**Report to the Future Melbourne Committee****Agenda item 6.3****Planning Permit Application: TP-2020-464  
University Square, 190-192 Pelham Street, Carlton****07 December 2021****Presenter:** Larry Parsons, Head of Statutory Planning**Purpose and background**

## DELEGATED PLANNING APPLICATION REPORT

<b>Application number:</b>	<b>TP-2020-464</b>
<b>Applicant:</b>	<b>The University Of Melbourne</b>
<b>Owner</b>	<b>Melbourne City Council (land manager) / Victorian State Government</b>
<b>Architect</b>	<b>Two Feathers Architects</b>
<b>Address:</b>	University Square, 190-192 Pelham Street, CARLTON VIC 3053
<b>Proposal:</b>	Use the land as a place of assembly, construct a building and carry out works, and waive the bicycle facilities requirement of Clause 52.34
<b>Cost of works</b>	\$600,000
<b>Date of application:</b>	10 July 2020
<b>Responsible officer:</b>	Ryan Cottrell

STATUS: ISSUE FOR CONSTRUCTION	353.9°
DRAWING TITLE: LANDSCAPING PLAN	SIZE: A3
DRAWING NUMBER: FD07-01	REVISION: 9

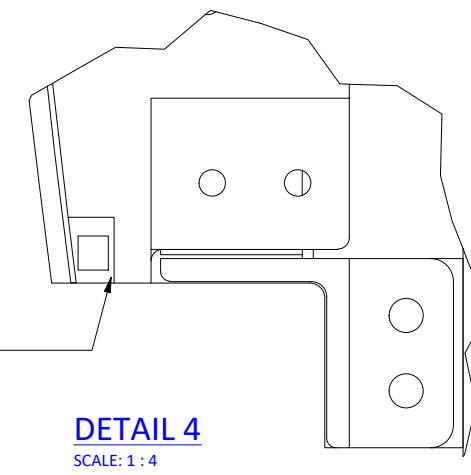
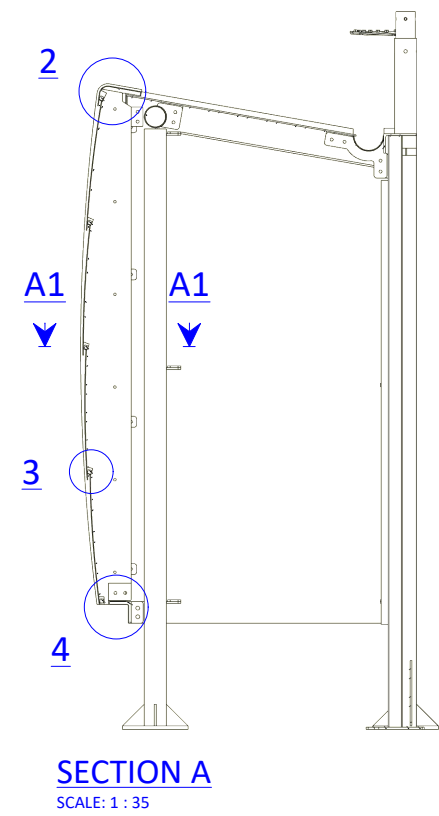
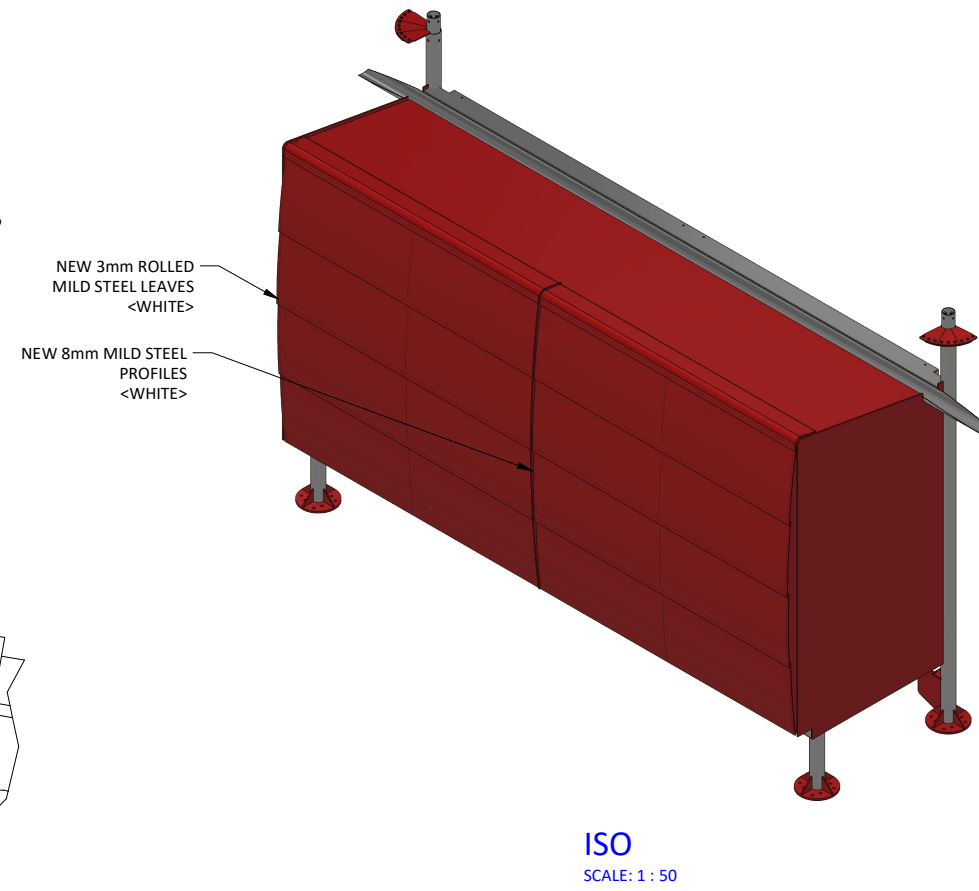
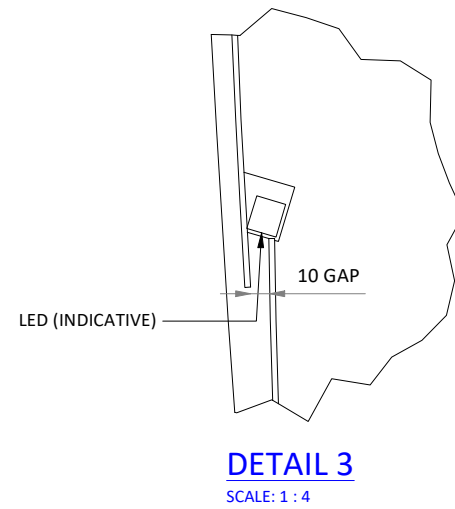
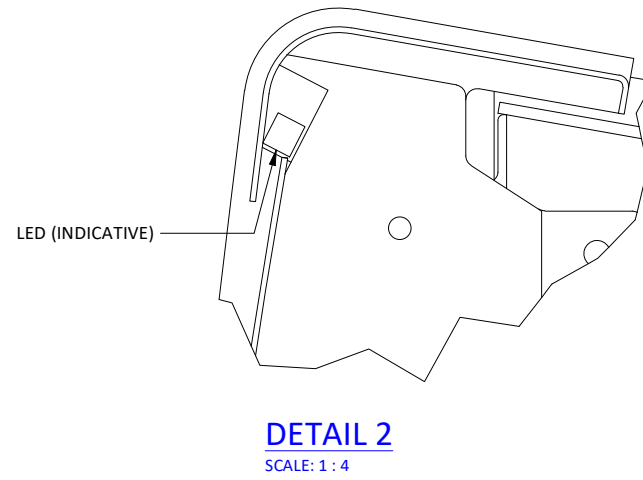
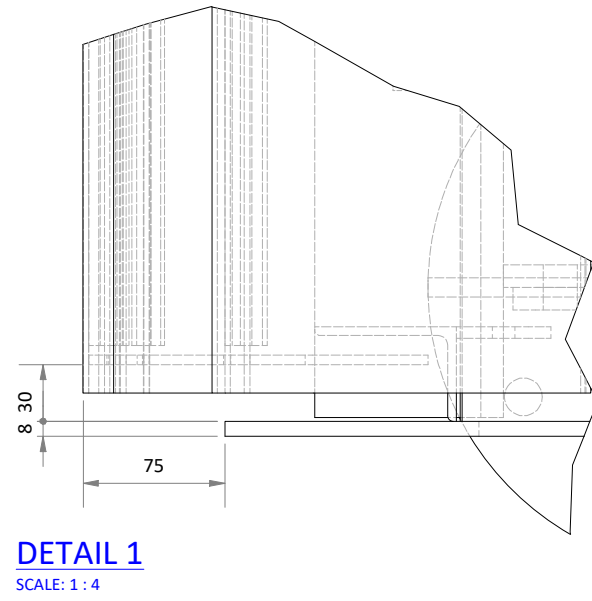
*The document FD07-01 Rev 9 Landscaping Plan needs to be revised to contain the same detail as the TPMP. This is only a minor edit"*

It is recommended the missing information shown in the Tree Protection Management Plan be included on the development drawings. It is recommended this be achieved via a permit condition.

1. Prior to the commencement of the use and development, or as may otherwise be agreed with the Responsible Authority, an electronic set of plans drawn to scale must be submitted to the Responsible Authority, generally in accordance with the advertised plans prepared by Two Feathers but amended to show:
  - a. The changes in the discussion drawings prepared by Two Feathers, titled FD07-01 (Rev 9), FD18-01 (Rev 9), FD18-03 (Rev 5), and FD18-04 (Rev 2).
  - b. Drawing (FD07-01 Rev 9) updated to contain the same detail as the Tree Protection Plan by Tree Logic, dated 29 September 2021.
